Exam Review Guide: Transportation, Volume 2

Errata

(Updated 2/16/23)

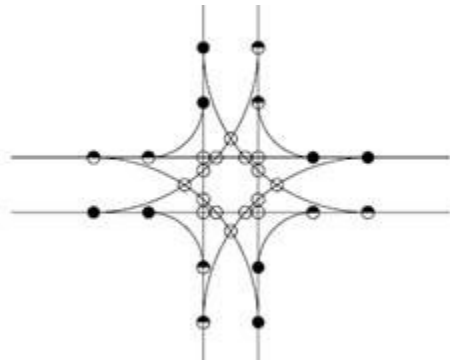
(1) Pg. 9-85, In figure 9.42, 32 conflict Points should look like the figure below
